# **RANCHO SANTIAGO COMMUNITY COLLEGE DISTRICT**

## **ADDENDUM NO. 02**

Bid #1434  
at  
CAMPUS ENTRANCE IMPROVEMENT – PHASE 1 PROJECT

Project ID #3739, DSA #04-121029

SCALE: N.T.S. 6

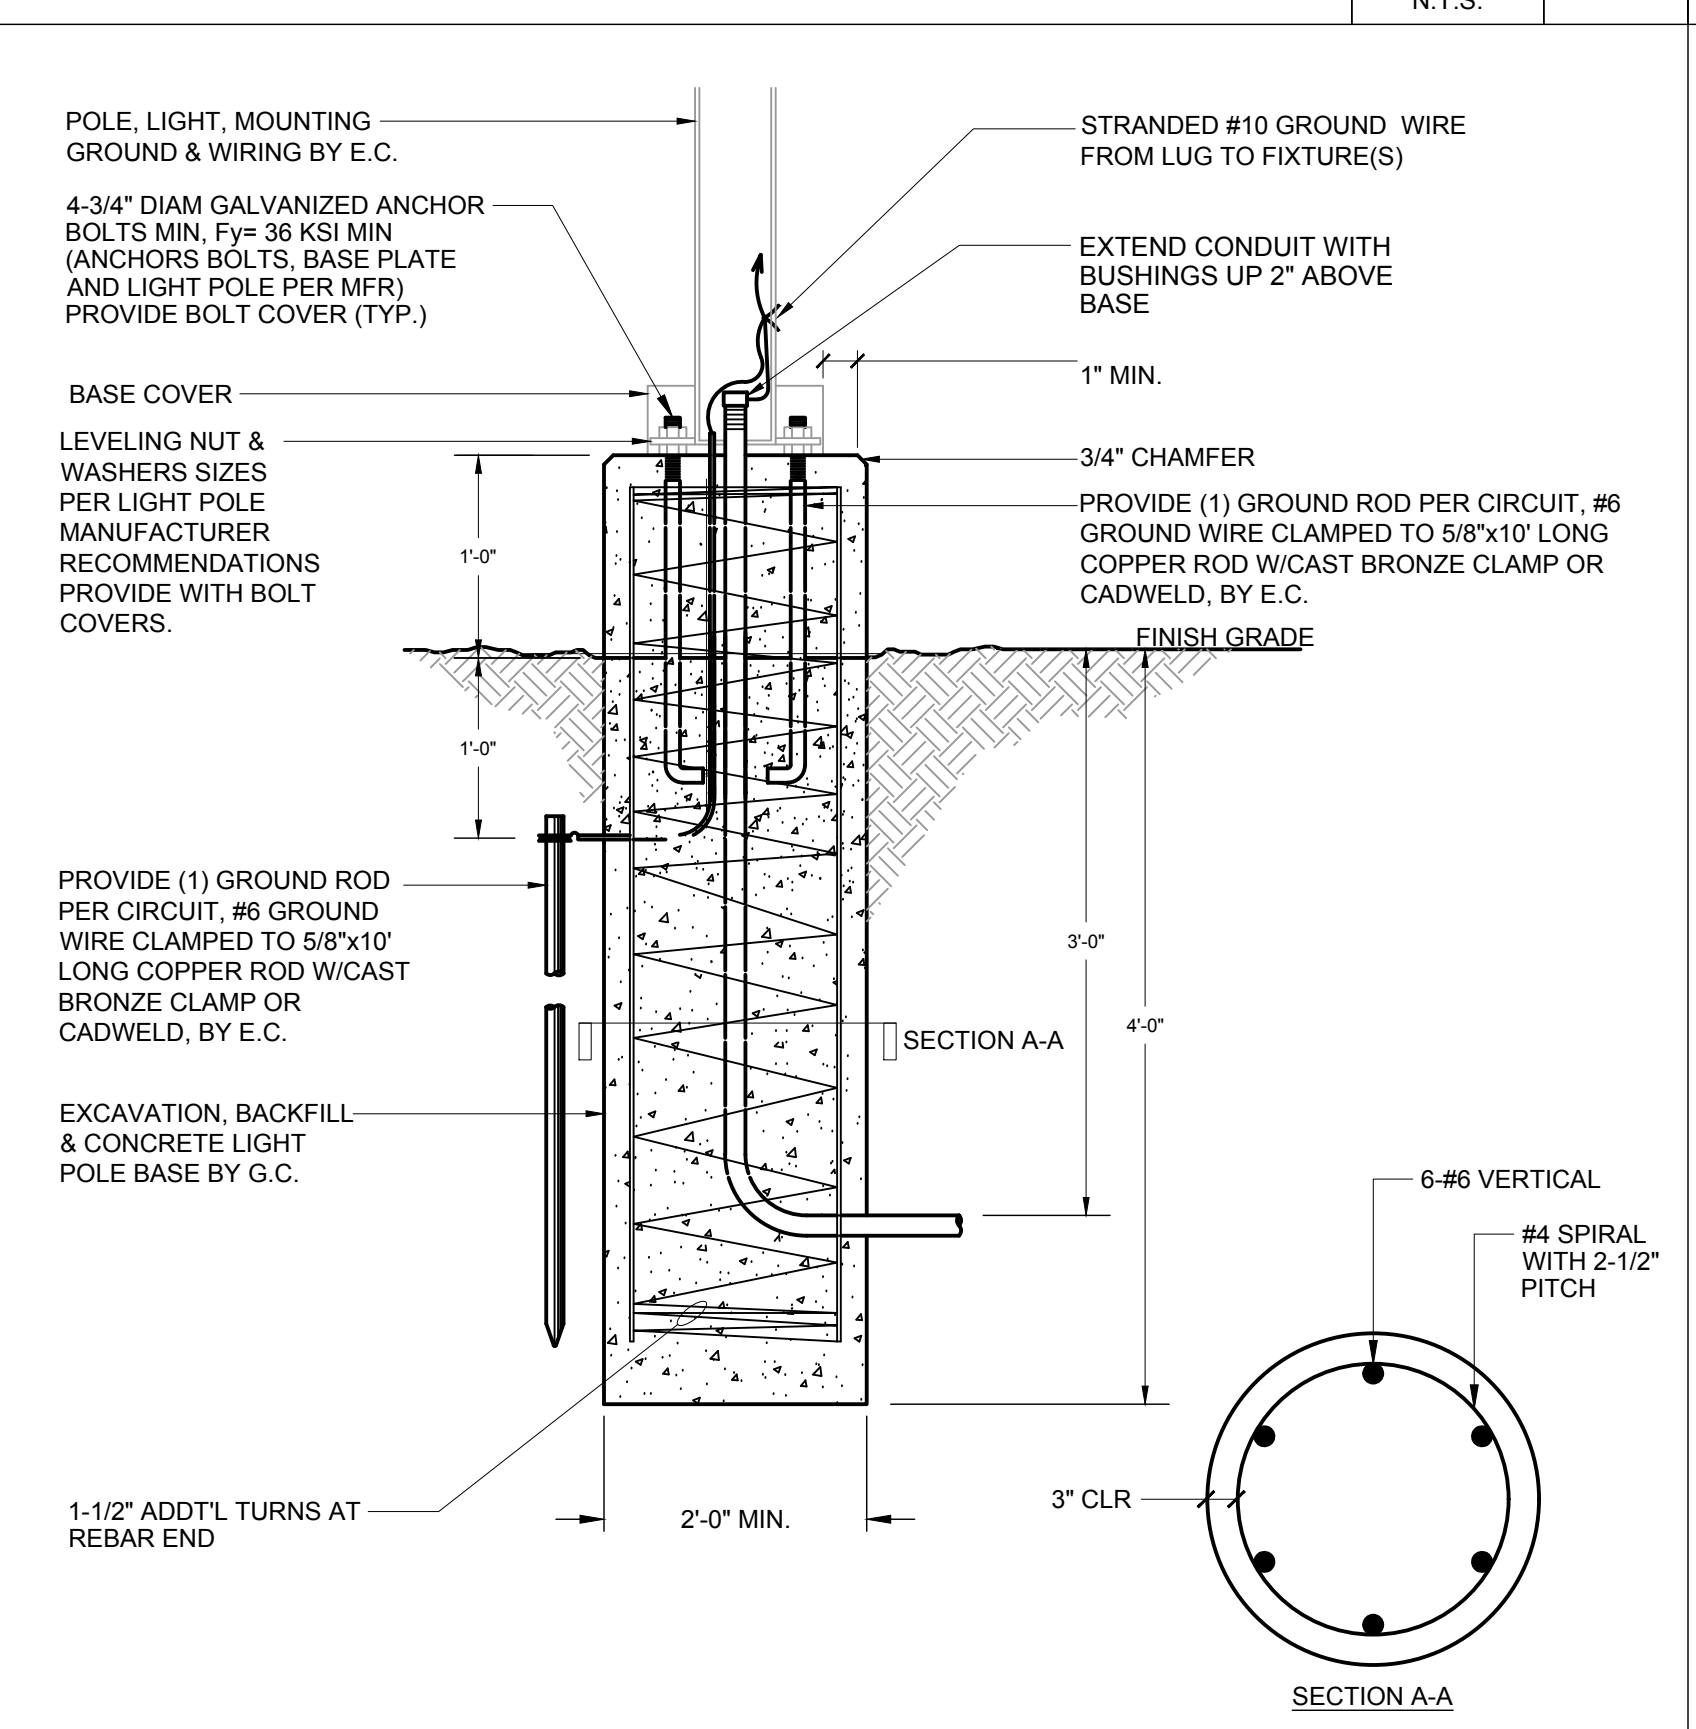
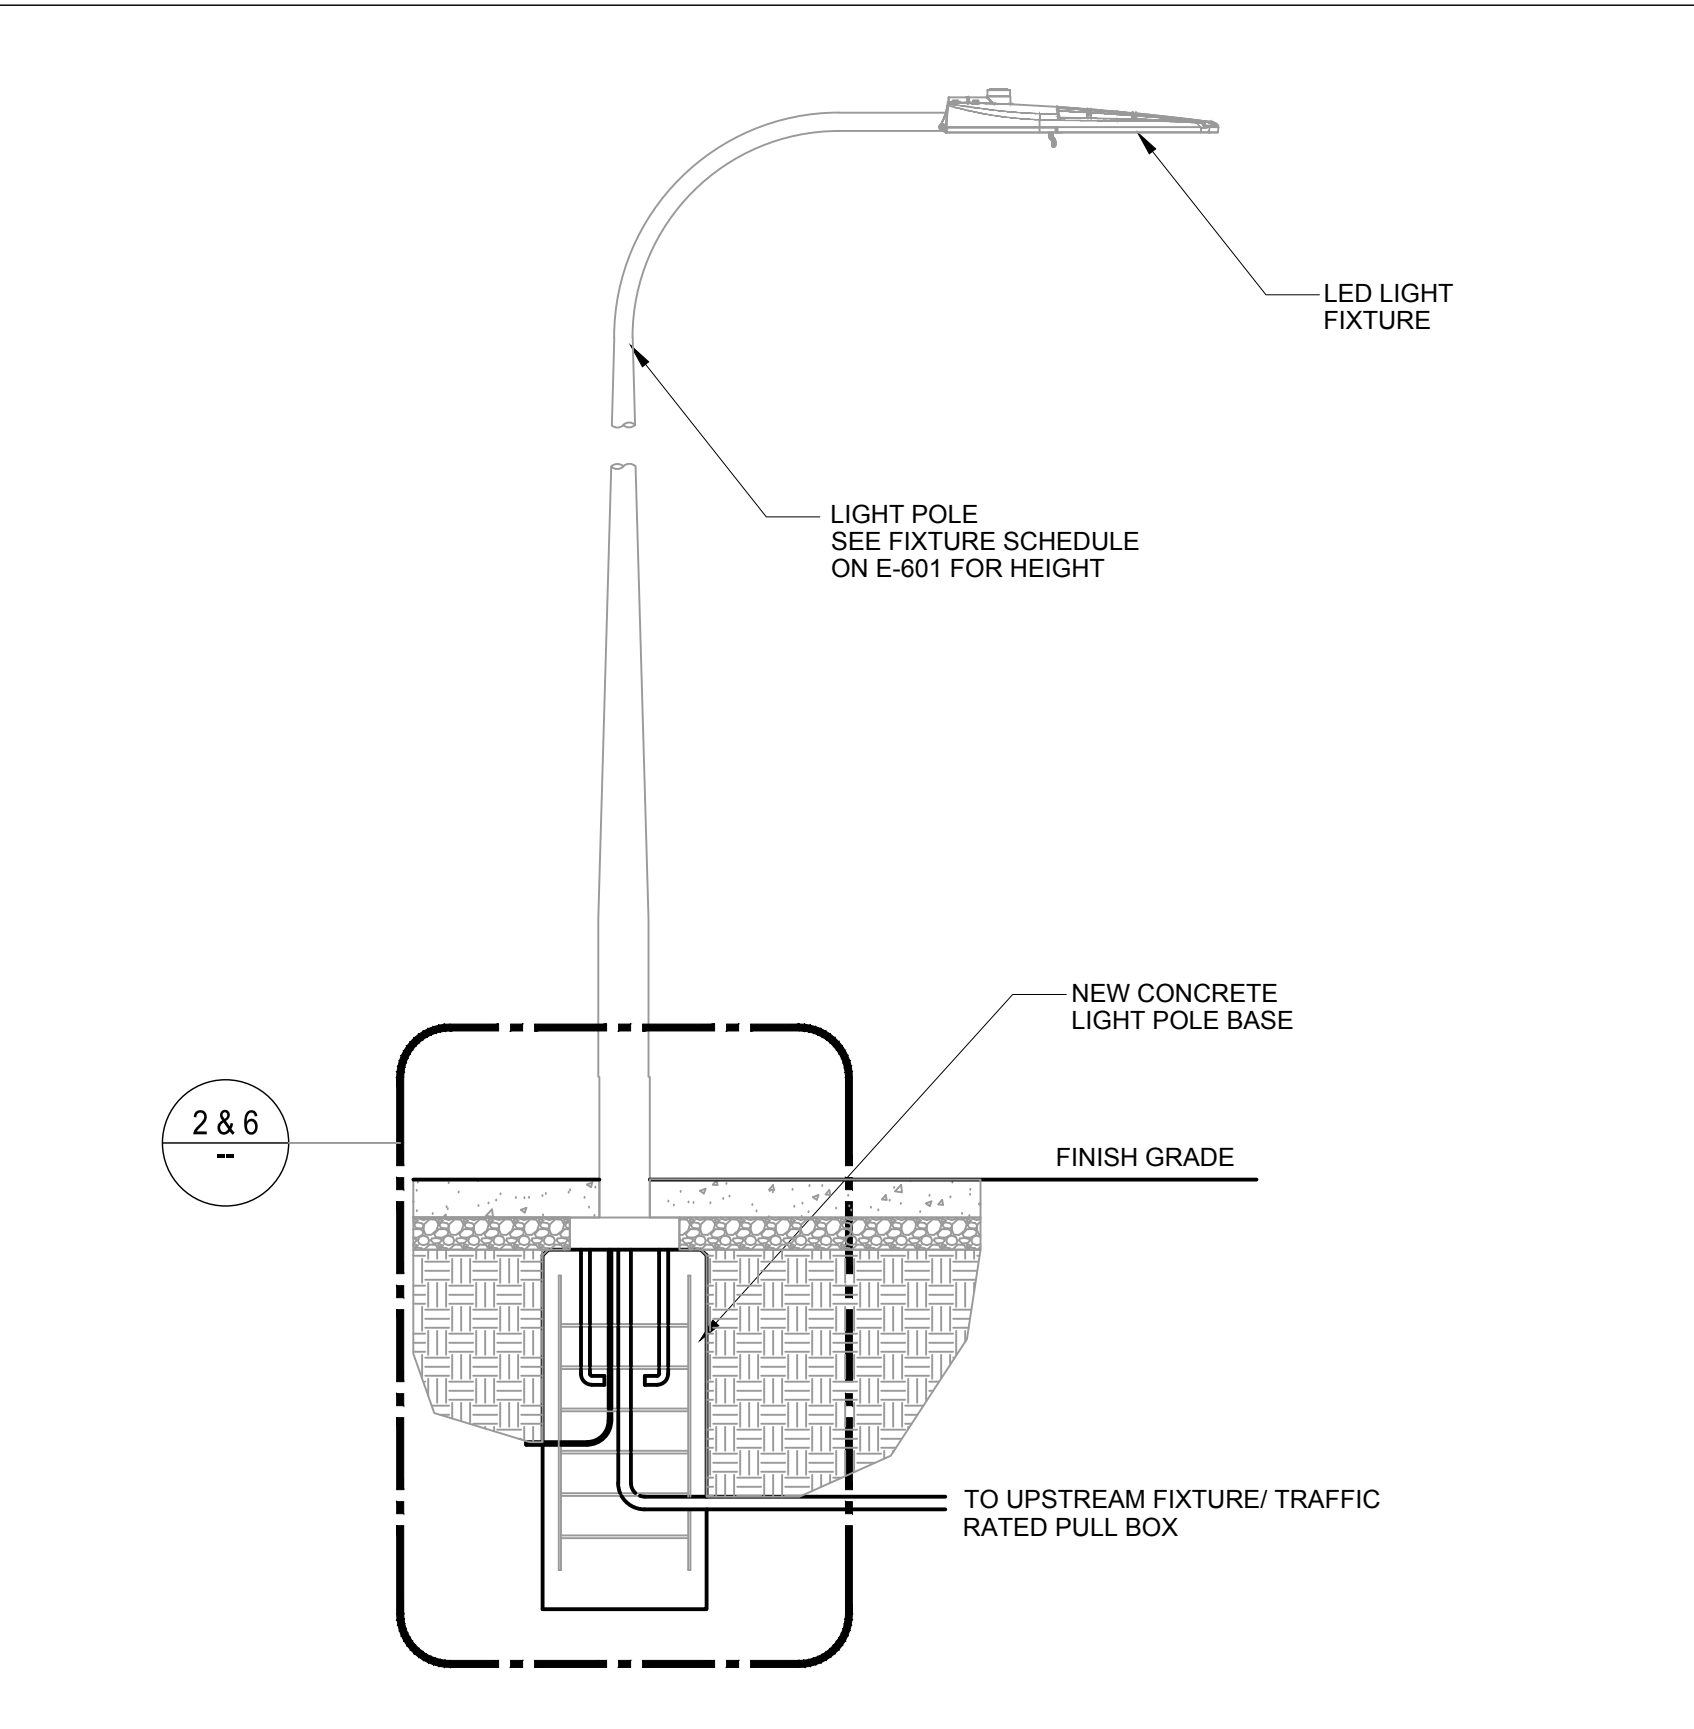
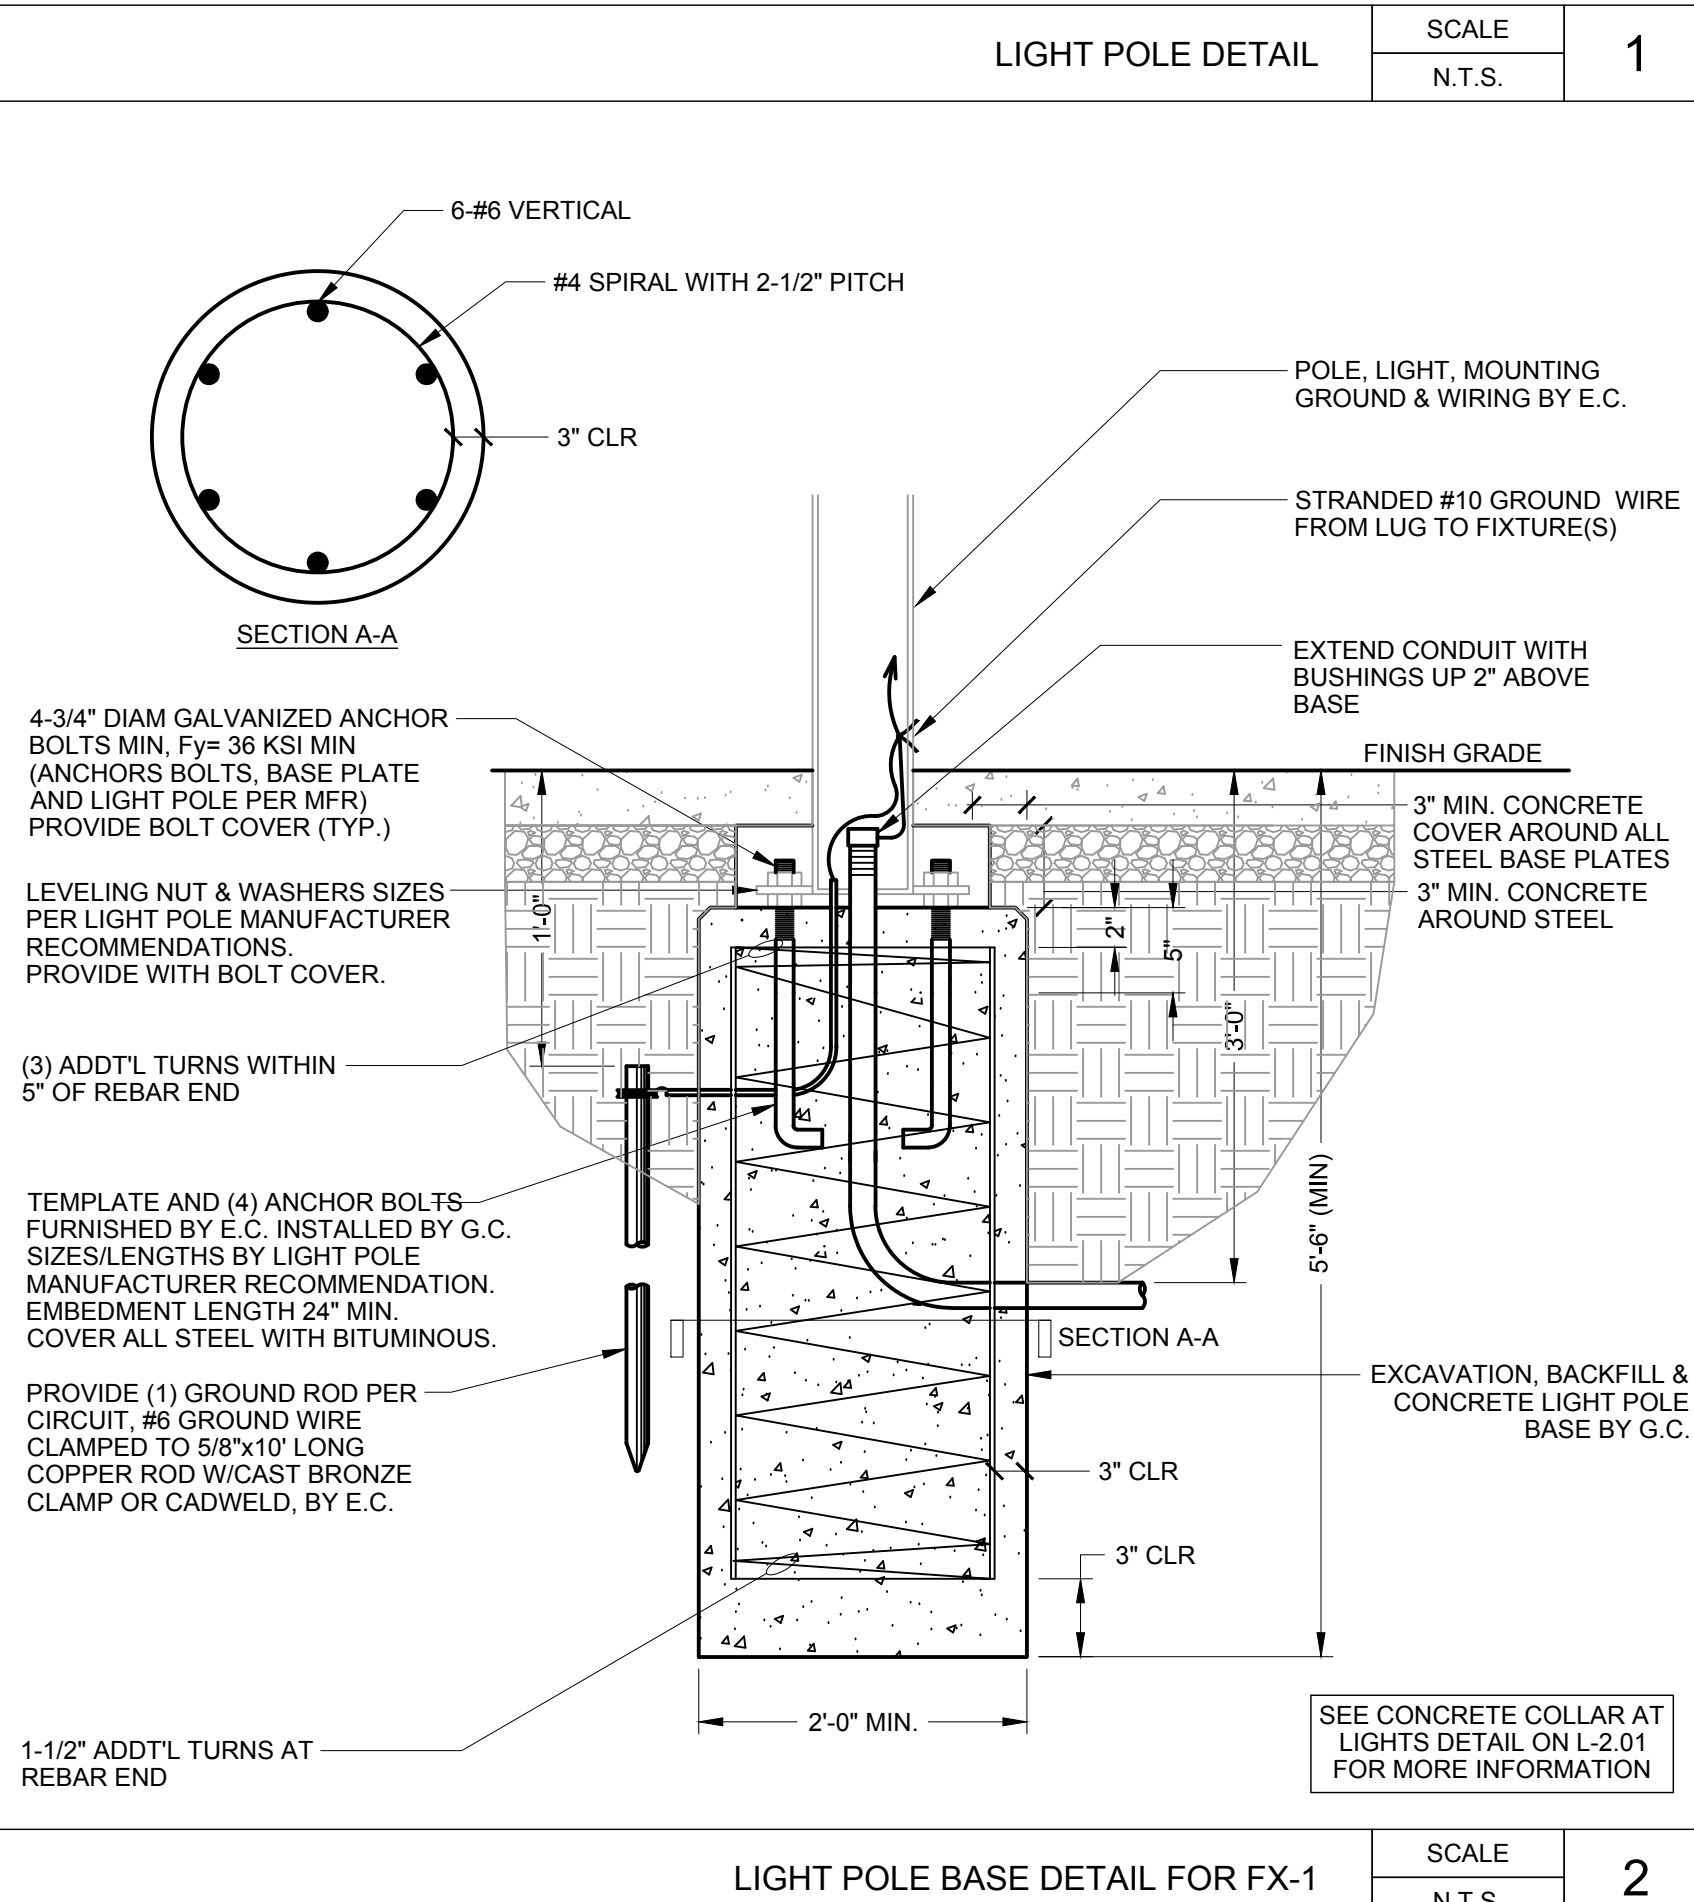
Provide a brief description of construction scope for this post-approval document (attach additional sheets if needed): <u>Updated sheets CD-1.3, C-4.1 &amp; C-5.2 to remove an existing gate valve by adding a note and detail. Revised note on Landscape detail G/L-4.01 to use PVC SCH.40 and detail H to use SCH.80 nipple MIPT and slip match valve size. Added note on sheet L-501 to add root barrier at trees within 8-ft. of hardscape. Added note #4 on 6/L-6.01 to add 4-inch mulch layer. Updated the electrical sheets to add a note and detail to add addition security cameras.</u>			
List of DSA-approved drawings affected by this post-approval document: <u>Civil sheet(s): CD-1.3, C-4.1, C-5.2, Landscape sheets: L-4.01, L-5.01, L-6.01 and Electrical Sheet(s): E-103 and E-501</u>
